Access Compliance Report

Public Rights-of-Way

Intersection ID: 43499	Main Street: MCALLISTER_PARK_DR	Cross Street: PRESCOTT_HILL_AV	Location: NE
ADA ID: FB444C49E84F	Ramp Type: BlendTrans2	Initial Pass/Fail: Fail	Overall Compliance: No
Severity Score: 18.75			
Codes/Mitigation Info/Possible Solution		Field Measurements/Component Compliance

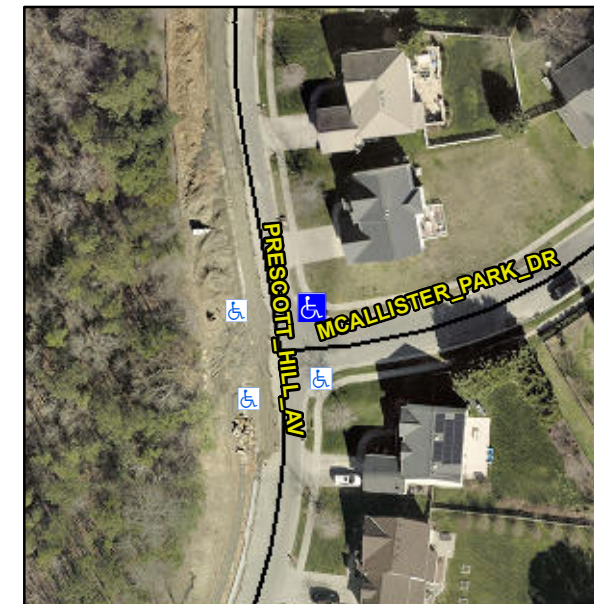
R304.5.1, R304.5.3

Compliance	Description	Data	Compliance	Description	Data
N/A	Ramp Length (in)	102.0	Yes	BlendTrans Slope (%)	3.9
No	Ramp Width (in)	33.0	No	BlendTrans XSlope (%)	4.5
N/A	Flare Type LT	N/A	N/A	Flare Type RT	N/A
N/A	Flare Slope LT (%)	N/A	N/A	Flare Slope RT (%)	N/A
N/A	Flare Traversable LT?	N/A	N/A	Flare Traversable RT?	N/A
N/A	Landing Length (in)	N/A	N/A	DWS Provided?	N/A
N/A	Landing Width (in)	N/A	N/A	DWS Contrast?	N/A
N/A	Landing Slope (%)	N/A	N/A	DWS Length (in)	N/A
N/A	Landing X Slope (%)	N/A	N/A	DWS Full Width?	N/A
N/A	Landing Curb? (Y/N)	N/A	N/A	DWS Offset (in)	N/A
N/A	Shared Landing?	N/A			
N/A	Gutter Ponding?	N/A	N/A	Gutter Slope (%)	N/A
N/A	Gutter Lip Ht (in)	N/A	N/A	Gutter X Slope (%)	N/A
N/A	Painted X Walk1?	No	N/A	Painted X Walk2?	No
	X Walk 1 Direction	To W		X Walk 2 Direction	To S
	X Walk 1 Width (in)	N/A		X Walk 2 Width (in)	N/A
	X Walk 1 Slope (%)	5.1		X Walk 2 Slope (%)	0.3
	X Walk 1 X Slope (%)	1.3		X Walk 2 X Slope (%)	3.2

N/A	Ramp inside XWalk1?	N/A	N/A	Ramp inside XWalk2?	N/A
	Road Slope (%)	2.3		Clear Space?	N/A
	Road X Slope (%)	3.0	N/A	Clear Space to XWalk (in)	N/A
N/A	Any Obstructions?	N/A	N/A	Storm Grate/Utility Hazard?	N/A
	Obstruction Type			Storm Grate/Utility Type	
		N/A			N/A
			Yes	Surface Condition? (G/P)	Good
			N/A	Curb Slope (%)	1.8

Remove & Replace Curb Ramp With Two New Directional Ramps or Equivalent.
